Re: Recall No.: 00V-076

Technical BULLETIN

YZF-R1K, KC, L, LC; YZF-R6L, LC, M, MC FACTORY MODIFICATION CAMPAIGN

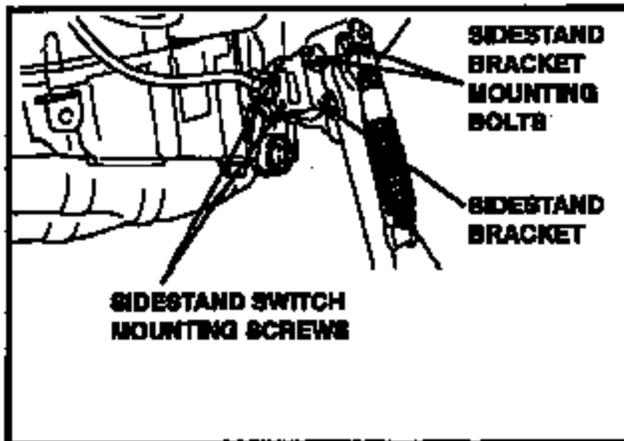
There was a mid-production change on 1999 YZF-R1 because a clamp was added to hold the fuel tank overflow hose and breather hose. The following motorcycles must be modified with Bolt Kit "B" which has longer bolts to accommodate the clamp on the switch:

All other affected YZF-R1 units as well as all affected YZF-R6 units use Bolt Kit "A."

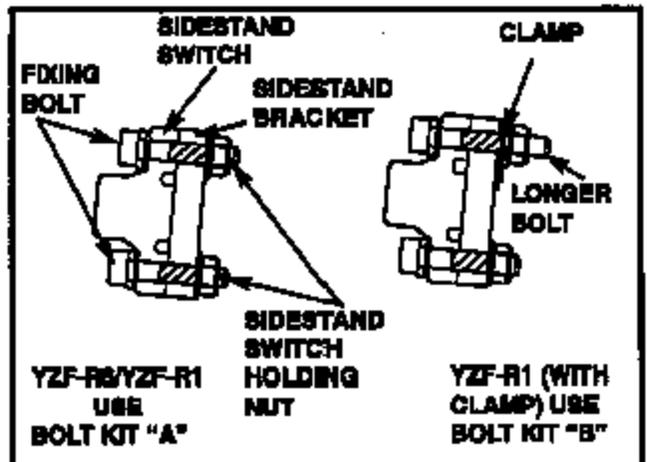
4. Assemble the sidestand switch again on sidestand bracket by installing the 2 new sidestand switch holding bolts from the kit.

Bolt Kit "B" is for YZF-R1 units with the clamp for hoses. Use the longer bolt in the top mounting hole where the clamp is located.

Tightening Torque: 3.8 Nm (0.38 m-kg, 2.7 ft-lb.)

5. Hold the bolts to prevent rotation, then install the 2 sidestand switch holding nuts from the kit.

Tightening Torque: 3.8 Nm (0.38 m-kg, 2.7 ft-lb.)
